Staff Report

To: The Hanahan Planning Commission
Cc: Fred Skipper (Bowen), Kevin Coffey (Lowcountry Land Development), Larry Sturdivant, Building Official
From: Jeff Hajek, Planner/Economic Development Director
Date: June 1, 2021
Re: Preliminary Plat Approval for Bowen Greenway

Applicant/Owner: The Wrenn Group
Location: Northeast of the Evening Tide Drive-Caisa Alley intersection
Tax Map Number(s): 259-00-00-170; 259-00-00-125
Approval Requested: Preliminary Plat Approval
Existing Zoning/Land Use: PD Development, Type B

CIVIL
 PRELIMINARY PLAT
 GREENWAY
 CITY OF HANAHAN
 BERKELEY COUNTY
 TMS 259-00-00-170

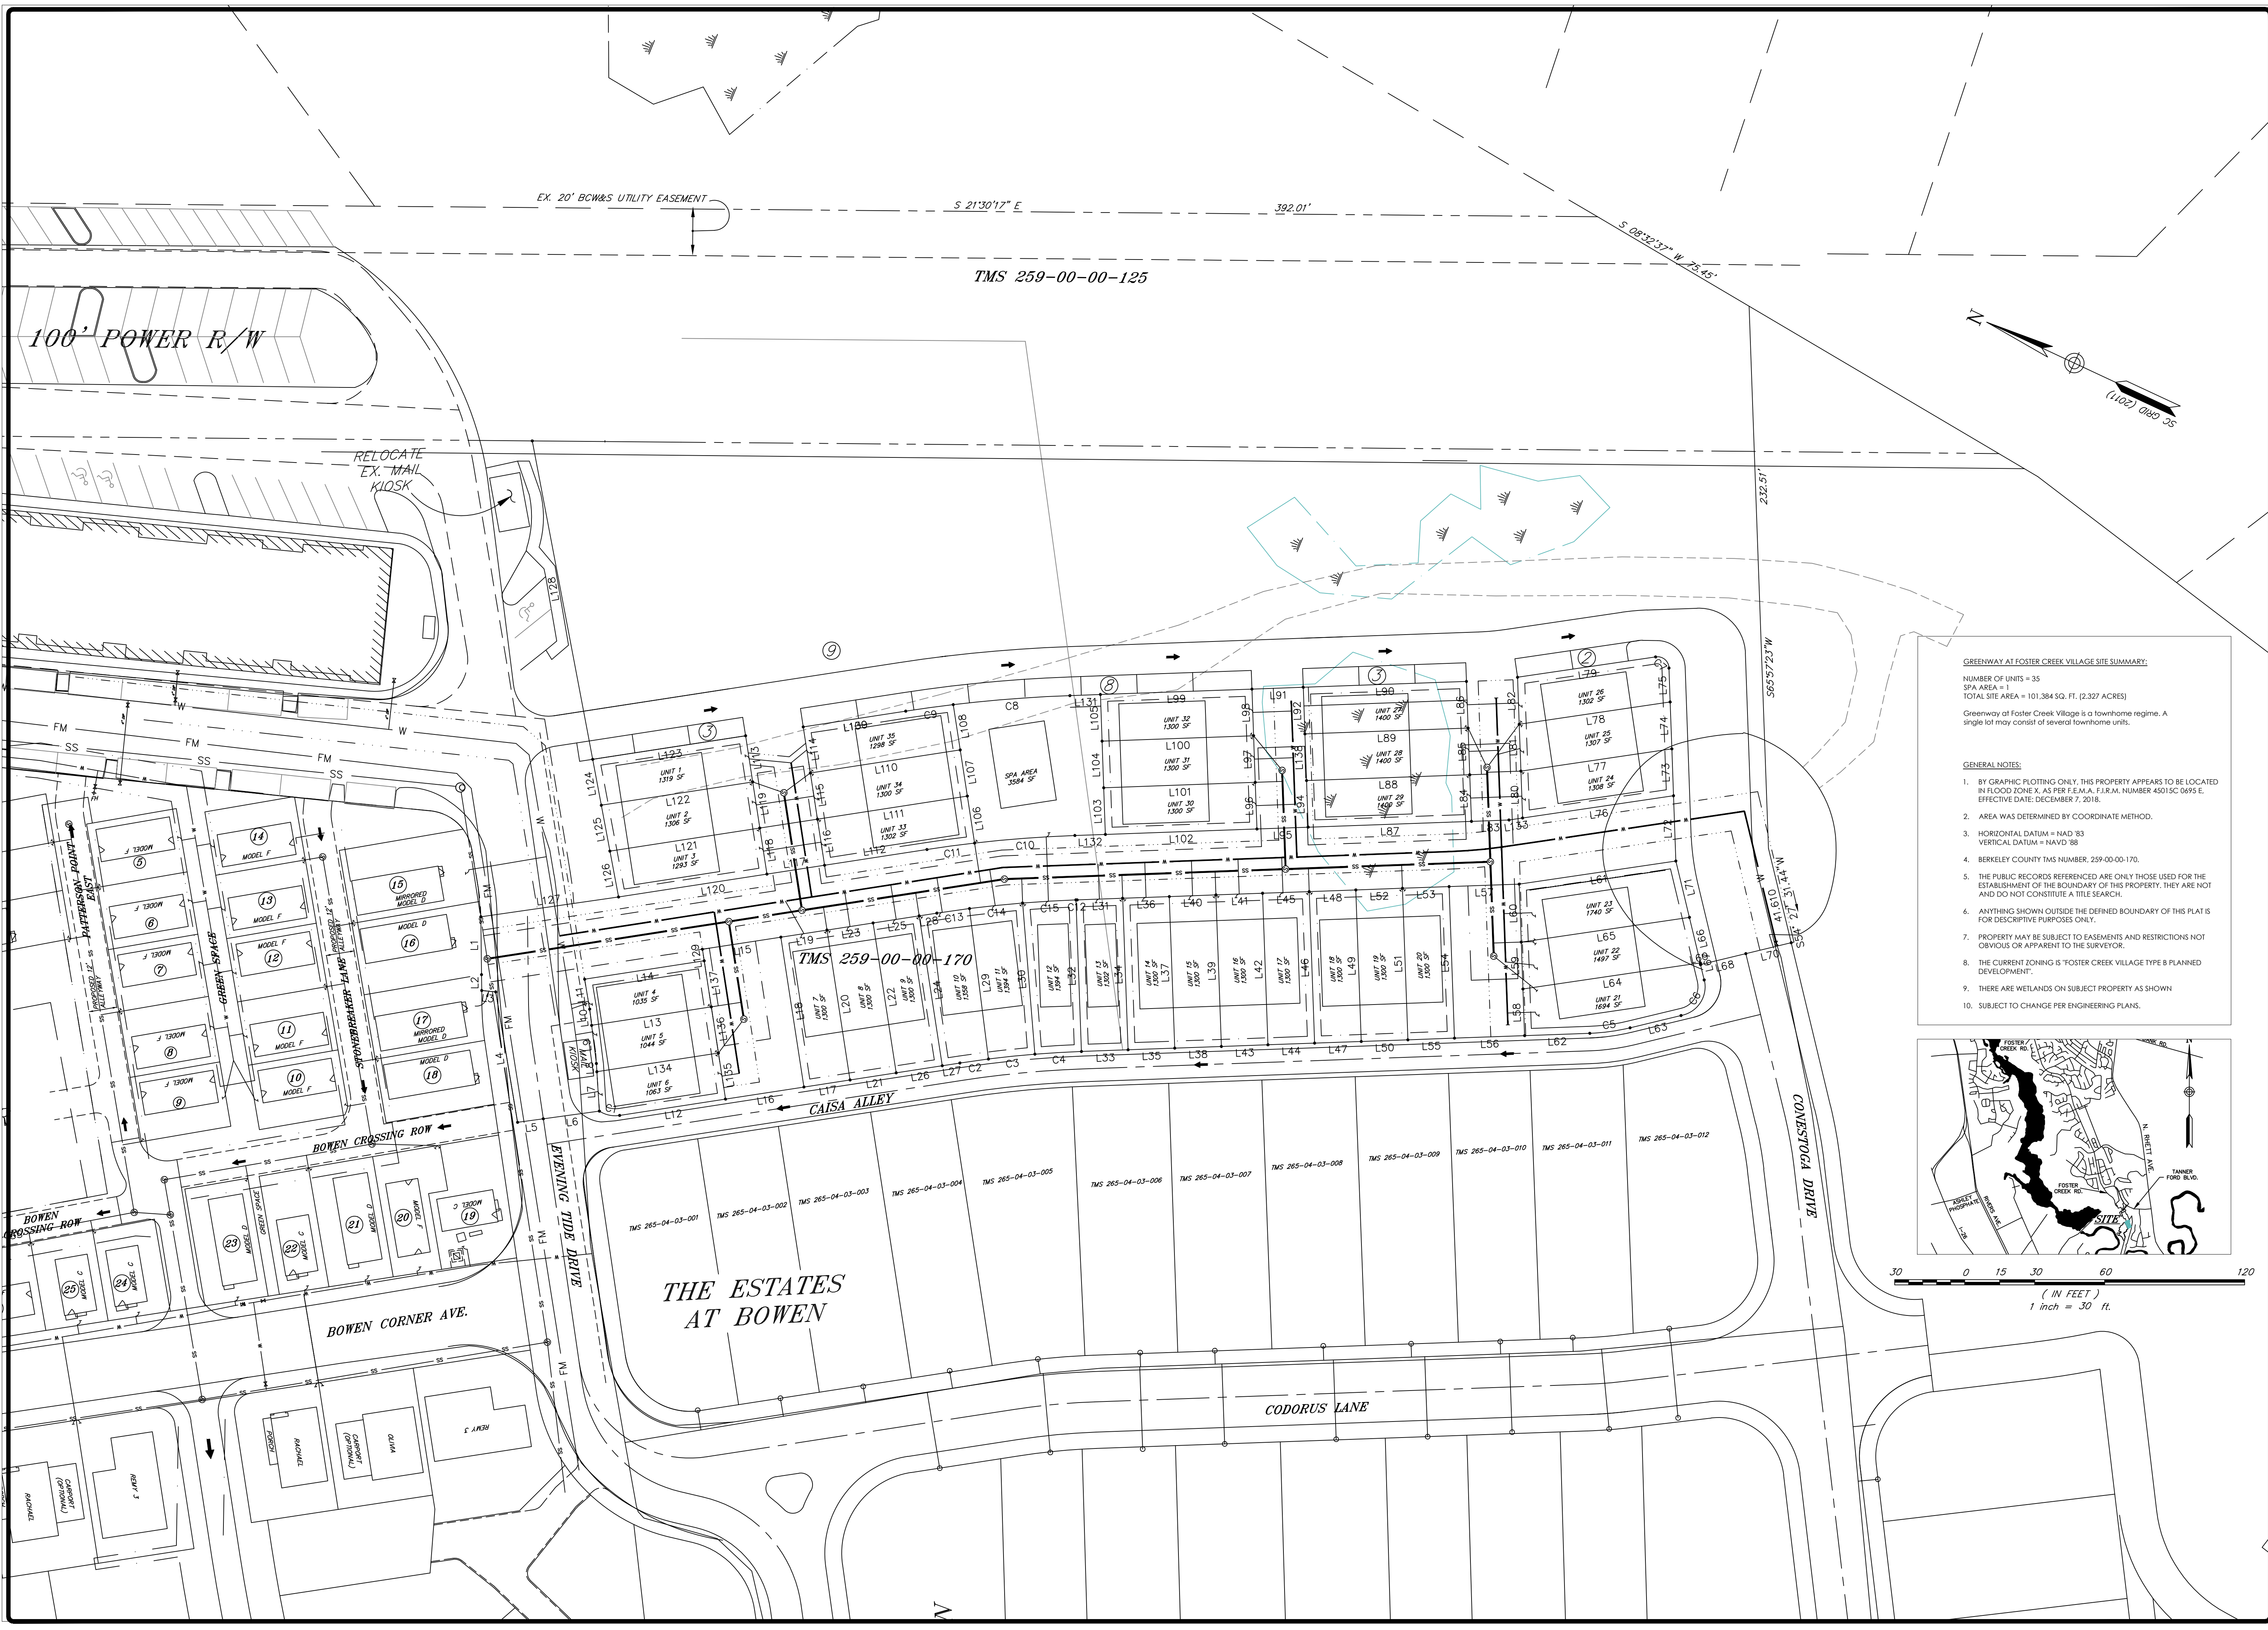
1. The proposed minimum lot size ***does not*** conform to the PD required minimum for FCV-MF of five (5) acres. The proposed acreage stated on the plat that the “Total Site Area” is 2.37 acres.

Additionally, if looked at through the FCV-TH (Townhome) district on a “by use” basis, the minimum lot size required is 2,500 SF. None of the 35 proposed lots do not meet this minimum either.

- a. For the second Planning Commission application, no changes were made to the proposed lot sizes, only the labels for each parcel were changed from “Lot” to “Unit.”
2. Lots appear to conform to the PD’s minimum 20-foot lot width requirement.
2. Density for the development is limited to 12 units per acre for the entire PD and open space requirements are calculated for the overall development.

(4) [Page 8]: Contours, showing the topography of the site at a vertical interval of one (1) foot, will need to be shown on the site plan.

(1) [Page 8]: Street rights-of-way, pavement widths, grades, and street names will need to be shown on site plan.

(4) Contour changes to be made by grading will need to be shown in a grading plan

(5) Setback measurements will need to be shown on site plan

5. Design Standards (F)(1) Streetscape (Pg. 6 of PD Document): "One canopy tree with a 2.5" caliper minimum diameter at breast height (DBH) spaced every 40' on center along both sides of all roadways shall be located within the private rights-of-way." These will need to be shown on the site plan or separate landscape plan.

A tree protection survey will need to be submitted for the development as this is a wooded, undeveloped piece of property. As included in the PD document and the 93' Zoning Ordinance, should a tree be within the buildable area it may be removed. However, per the Zoning Ordinance all trees 10" DBH or greater are protected. As such, mitigation will be required should the total amount of trees removed be greater than 25% of trees on the parcel. The required mitigation, per Section 903.2, will be a 1:1 ratio of whatever amount of trees are removed (i.e. 20 trees removed, requires 20 replacement trees be planted), with a caliper per tree being 2".

Per the PD document's Land Use Table (Pg. 14), each townhome or single-family detached home will be required to have at least two (2) parking stalls. These numbers should result in a total of 70 stalls minimum. Said stalls will need to be shown on site plans when building permits are submitted, or else they will be rejected.

1. Applicant must correct all proposed lot sizes to be in accordance with the "FCV-MF" district, as stated in the "General Conformance Analysis" section.

2. Complete requested corrections under the “General Conformance Analysis,” specifically #1 (minimum lot size)
3. Complete all requested corrections under the “Preliminary Plat Approval Requested Corrections (1984 Subdivision Regulations)” section
4. Complete all requested corrections under the “Preliminary Plat Approval Requested Corrections (FCV PD, Type B Document)” section
5. Complete all requested corrections under the “Preliminary Plat Approval Requested Corrections (1993 Zoning Ordinance)” section
6. Applicant must provide a tree mitigation/protection plan for oaks stated by lot number in the Tree Protection Survey of the report. Completion of this will be contingent upon the receipt of building permit approval.
7. Receipt of recommendation/approval letters from CWS, BCWS and Berkeley County Engineering.
